Change Order

PROJECT (<i>Name and address</i>): Rapid City Utility Maintenance Facility Rapid City, South Dakota	CHANGE ORDER NUMBER: 002 DATE: February 19, 2015	OWNER: <input checked="" type="checkbox"/> ARCHITECT: <input checked="" type="checkbox"/> CONTRACTOR: <input checked="" type="checkbox"/> FIELD: <input type="checkbox"/> OTHER: <input type="checkbox"/>
TO CONTRACTOR (<i>Name and address</i>): SECO Construction, Inc. P.O. Box 2921 Rapid City, SD	ARCHITECT'S PROJECT NUMBER: 13373 CONTRACT DATE: September 17, 2014 CONTRACT FOR: General Construction

- RFP #006 - Add automatic shut down on HVLV fans / sprinkler flow - Add: \$1,553.00
- RFP #007 - Increase height of mezzanine floor - Add: \$4,574.00
- RFP #008 - Omit clean rock at all overhead doors - Deduct: (\$1,690.00)
- RFP #009 - Omit dampproofing at foundation walls - Deduct: (\$2,686.00)
- RFP #010 - Modify electrical chain hoist / trolley - Deduct: (\$1,637.00)
- RFP #011 - Hardware change per owner request - Add: \$5,924.00
- Total Add: \$6,038.00

RFP #: 7	CITY OF RAPID CITY UTILITY MAINTENANCE FACILITY	13373	A1
REVISED FIRST FLOOR PLAN - B1/A-101			
Scale: 1/8" = 1'-0"	DATE: 12/10/14

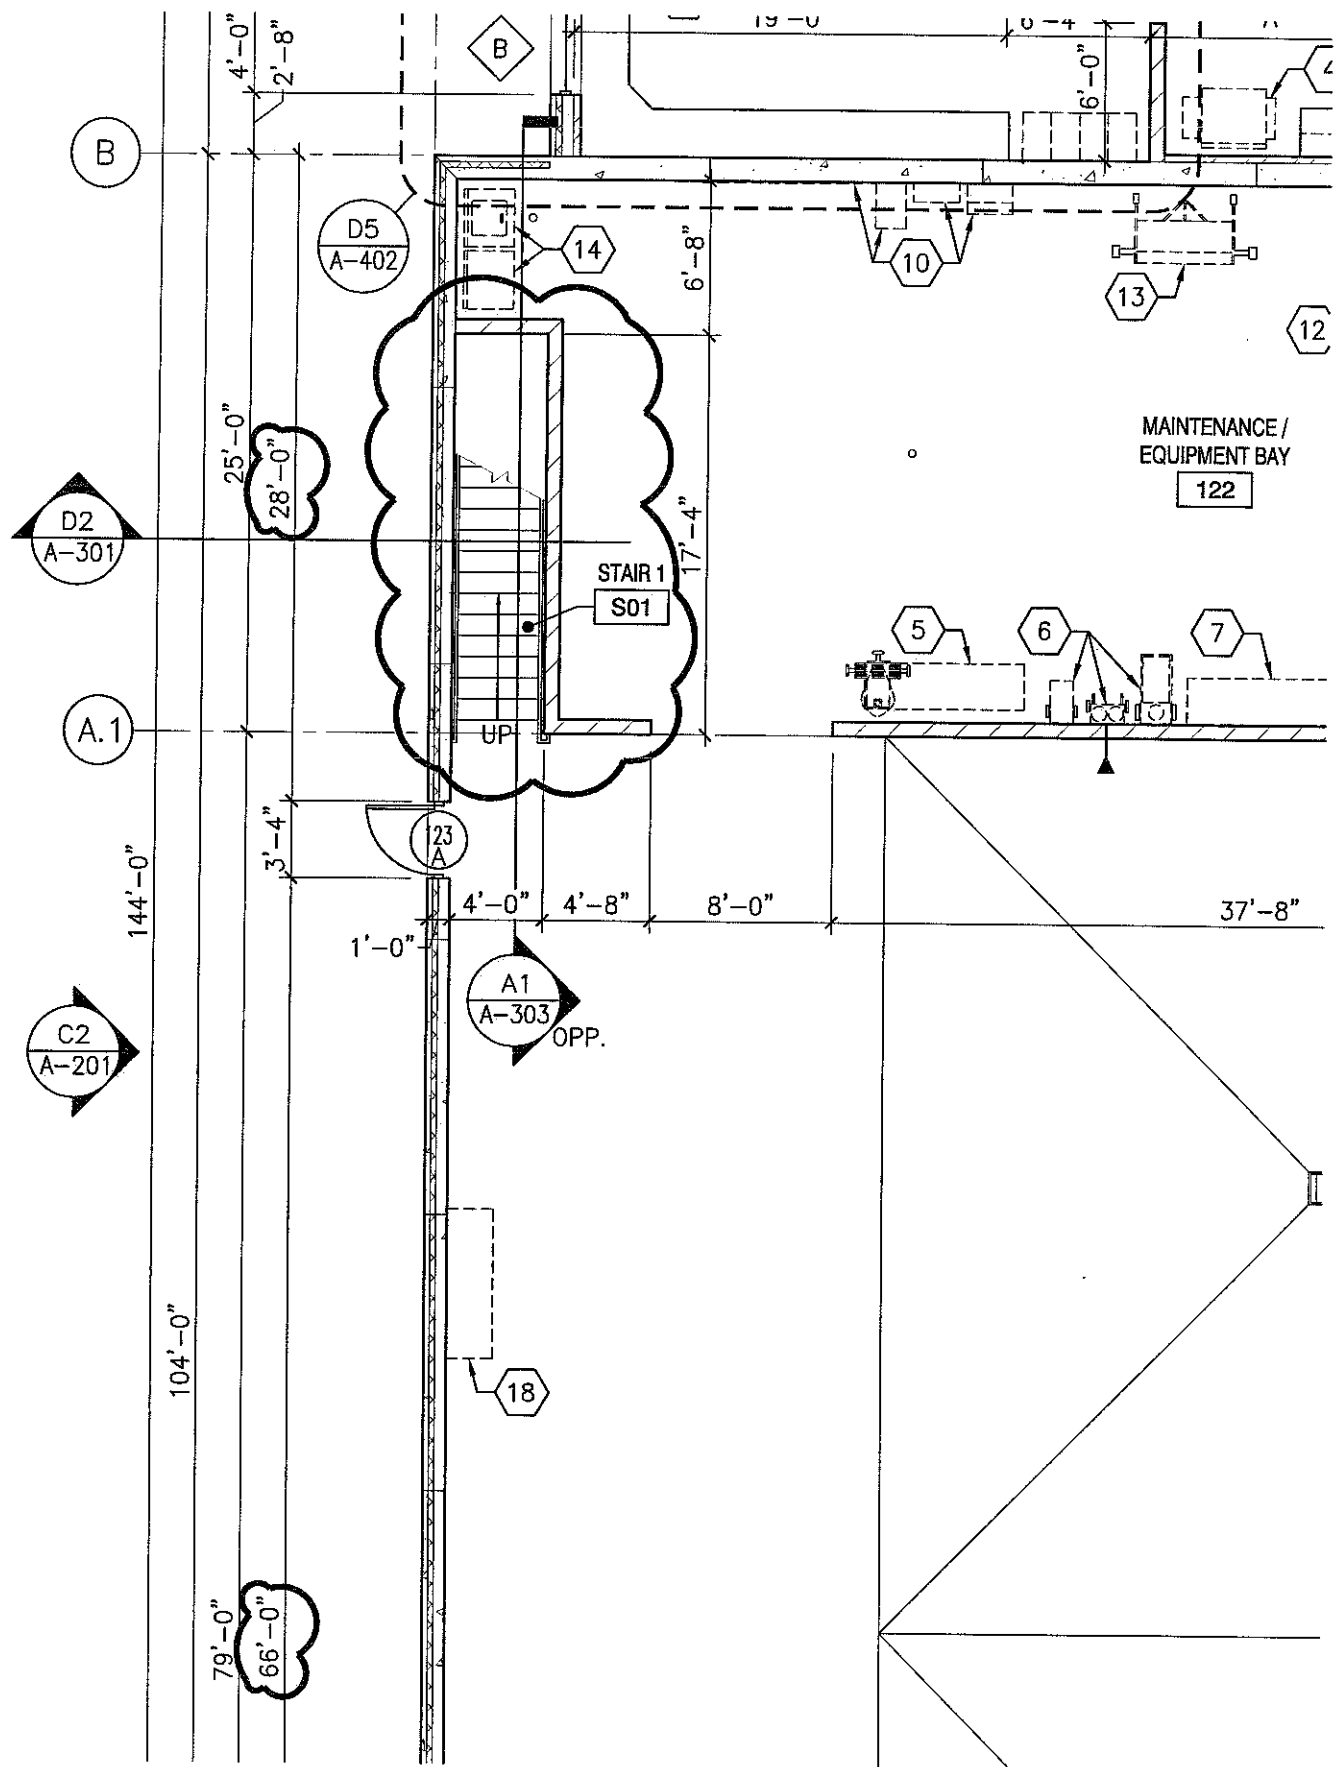
Provide costs associated with raising mezzanine floor 8" from elevation 110'-3" to 110'-11". Change of floor height will require modification to stair stringer and handrails, relocation of door and stoop at 123A and reduction in steel column height. The three masonry lintels shall be raised 8" as shown on attached drawing A2. Modification has been coordinated with precast shop drawings.

<p>SKYLINE ENGINEERING LLC</p> <p>615 12th Street Rapid City, SD 57701</p> <p>Tel: 605.737.3800 Fax: 605.737.3859</p>	PROJECT CITY OF RAPID CITY UTILITY MAINTENANCE FACILITY		SHEET ESK1	
	SHEET TITLE ELECTRICAL DETAILS		REF SHEET: E-700	
	PROJECT NO. 13028	DRAWN BY SMD	CHECKED BY JBS	DATE: 1-22-15

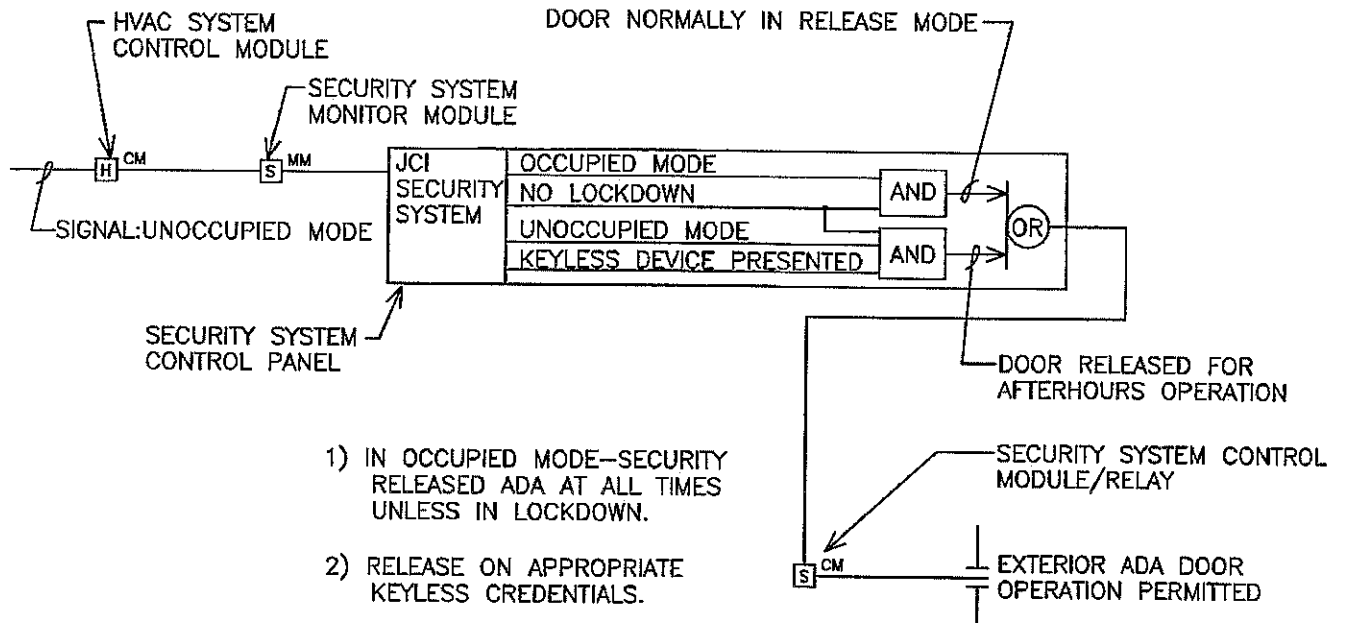
- Electrical Sheet #301 Main Level Signal Plan:
 - a. Card Access - Security system to add interface with HVAC. Coordinate interconnection with HVAC and ADA release unit with security system. See attached interlock. Card access to also add a release relay at ADA operator.
